GROUP	MODEL
ELE	2024MY EV9 (MV)
NUMBER	DATE
339	June 2024

TECHNICAL SERVICE BULLETIN

SERVICE ACTION: ICCU-VCU S/W UPGRADE FOR EWP OPERATION AND ICCU REPLACEMENT (SA570)

Flowchart:

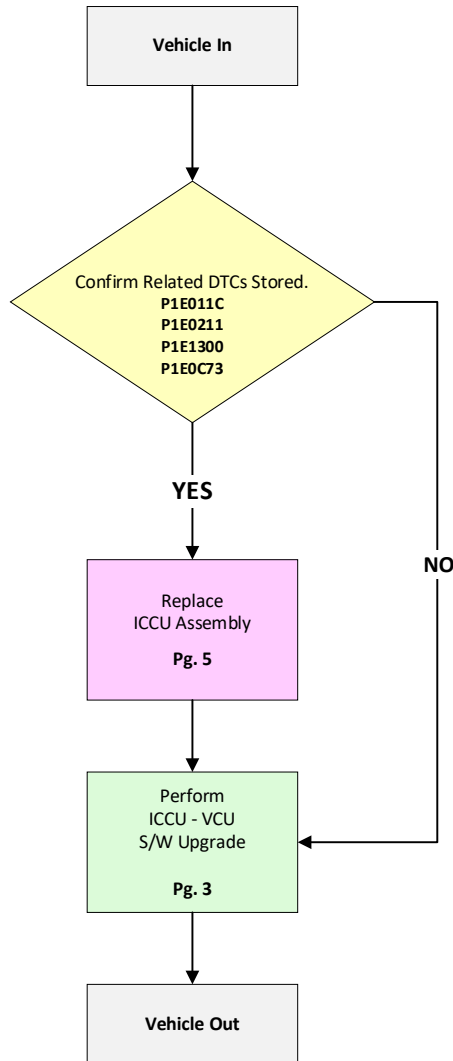
Path 1: Vehicle IN → Related DTCs Stored (NO) → ICCU - VCU S/W Upgrade → Vehicle OUT

Path 2: Vehicle IN → Related DTCs Stored (YES) → Replace ICCU ASSY → ICCU - VCU S/W Upgrade → Vehicle OUT

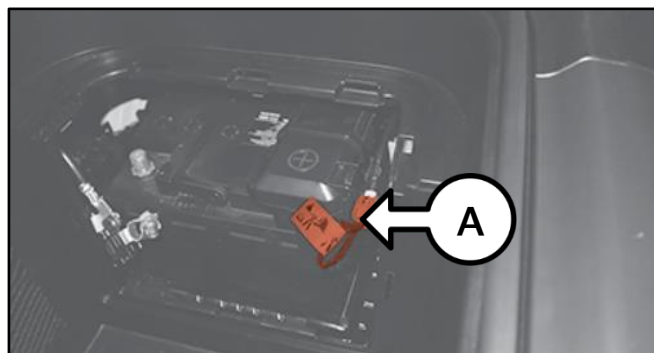
1. Related DTC(s) stored.

If any non-related (other than those listed below) DTC(s) are stored, refer to KGIS to further diagnosis then proceed to 'ECU Upgrade Procedure' on page 3.

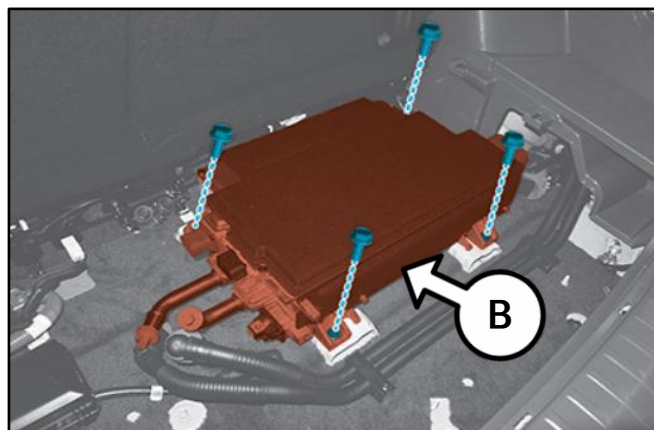
2. Perform the '**High Voltage Shut-Off Procedure**' (A) by referring to "Body Electrical System → High Voltage Shut-Off Procedures → High Voltage Shut-Off Procedures (**Steps 1-2 Only**)" in the applicable Shop Manual on KGIS.

3. Replace the Integrated Charging Control Unit (ICCU) (B) by referring to "Battery Control System → High Voltage Charging System → Integrated Charging Control Unit (ICCU) → Removal and Installation" in the applicable Shop Manual on KGIS.

Tightening torque for bolts:
16.6 - 19.5 lb.ft (22.6 - 26.5 N.m)
